EXPERT ANALYSIS OF PROPOSED BORDER WALL AND BUOY SYSTEM ON THE RIO GRANDE RIVER IN WEBB AND ZAPATA COUNTIES, TEXAS, USA

PREPARED FOR: Rio Grande International Study Center
PREPARED BY: Mark R. Tompkins, PE, Ph.D, FlowWest
DATE: 03/10/2026

FIGURE 3 – RIO GRANDE FLOW AND STAGE AT THE COLUMBIA BRIDGE FROM 2010 TO 2026.

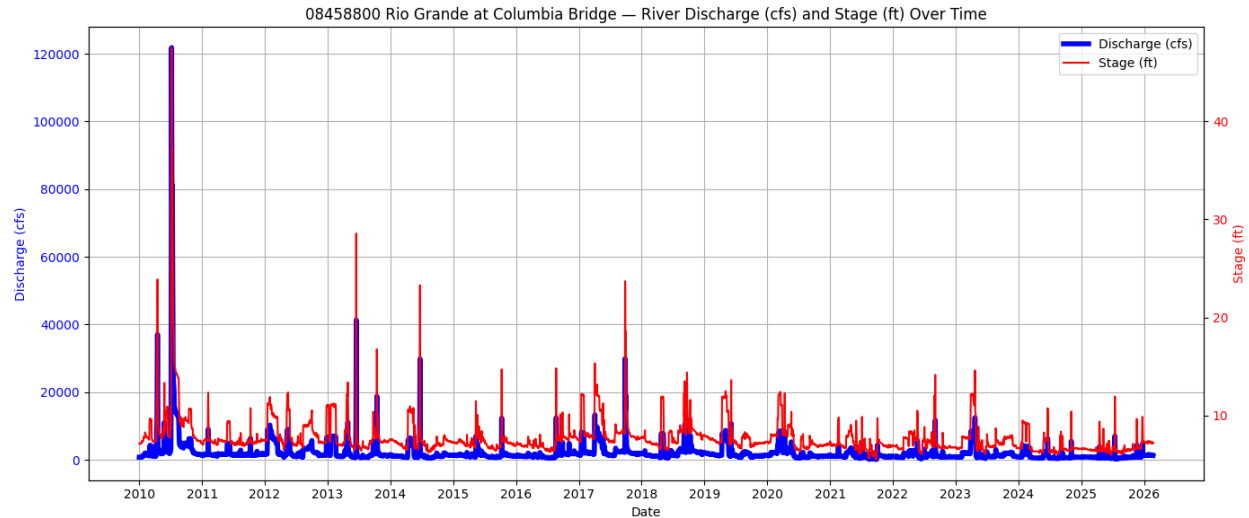
Hydraulic risk relates to the ways in which the proposed system will alter how water flows through the Rio Grande River. The Rio Grande currently experiences extreme high flows that cause flooding and related damage in Webb and Zapata Counties without the obstructions added by the proposed system. Figure 3 and Figure 4 summarize recent river flows and stages and impact summaries for recent floods, respectively. While the period from 2019 to present has experienced relatively low flow conditions, the period between 2010 and 2018 experience several major flood events. The wall portion of the system will create vast new areas (equal to approximately 35% of the river area itself) along the river that will be hydraulically smooth. In addition, the buoy portion of the system will result in a large new obstruction to flow (up to approximately 8% of the conveyance area of the river channel) in the Rio Grande. Together, the proposed wall and buoy system will result in increased velocities along the smoothed and cleared bank on the U.S. side of the river, elevated flood stages and backwater effects due to lost conveyance area, and flow redirection and increased turbulence due to the dangerous combination of cleared river bank areas adjacent to the continuous flow obstruction caused by the massive chains of buoys. It seems as though the design of the proposed system is intended to increase erosion of the U.S. riverbank and raise water levels throughout the river. During high flows like those experienced between 2010 and 2018, the proposed system will lead to failures in the already stressed flood control system in Webb and Zapata Counties.

FIGURE 5: MAPPED FLOOD ZONES AND CRITICAL INFRASTRUCTURE ALONG THE RIO GRANDE RIVER IN WEBB COUNTY.

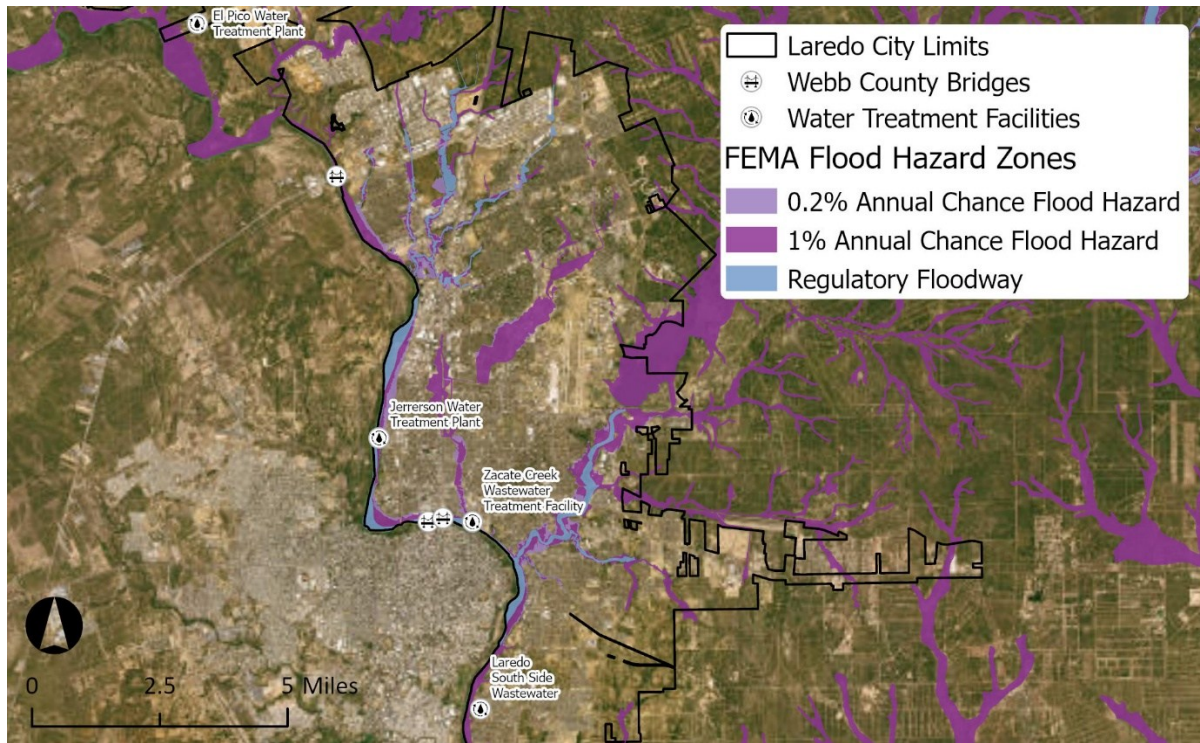
Figure 5 and Figure 6 show the existing flood hazard zones along the Rio Grande for Webb County. In addition, these figures show the locations of bridges, water treatment plants, and wastewater treatment plants. All of this critical infrastructure is in the existing flood hazard zone, meaning that it will be inundated during extreme events. Figure 7 shows how the existing flood control system is already stressed during high flows. The higher flows in the 2010 image in Figure 7 clearly inundate areas well

FIGURE 8: HISTORICAL LOCATIONS OF SIGNIFICANT CHANNEL CHANGE ON THE RIO GRANDE RIVER ALONG WEBB COUNTY.

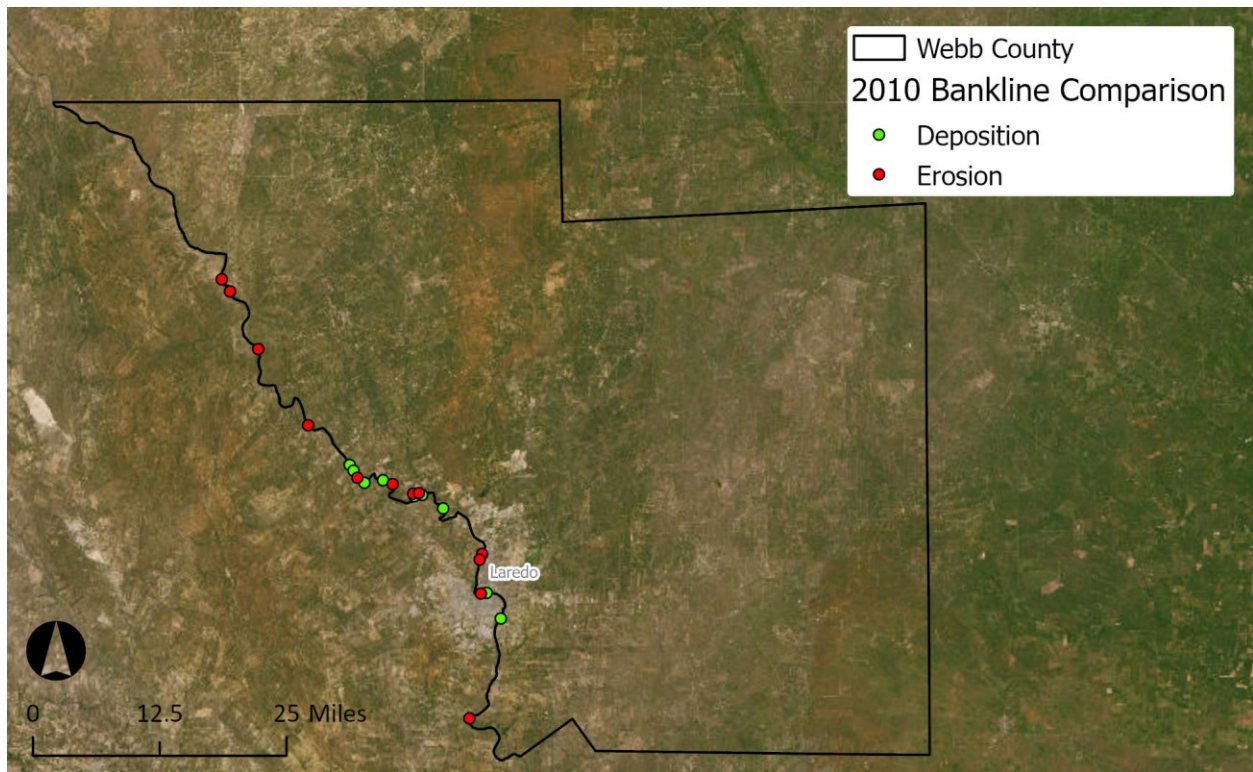
Alterations to the border location from erosion and channel migration are most likely at river bends and areas upstream and downstream of tributary inflows. Figure 8 shows locations of significant historical channel change that has occurred without the proposed project in place. This includes channel migration, bank erosion, and in-channel island formation. Channel change is likely to accelerate in these areas if the proposed system is constructed. Figure 9 and Figure 10 show major island growth and bank erosion, respectively, that has occurred in Laredo. It is extremely important to note that this change has occurred over only fourteen years, which is an extremely small time increment in the evolution of a river like the Rio Grande. The proposed wall and buoy system will greatly increase the geomorphic risk along the river, with accelerated evolution along the U.S. side caused by the denuded channel banks and the proposed border wall. These geomorphic risks will remain even if the proposed border wall is replaced with an earthen berm. Similar to hydraulic risk, the geomorphic risks will be exacerbated during high flows when debris loading focuses the erosion and scour onto bare channel banks and causes rapid and extensive channel migration along the U.S. bank of the river.
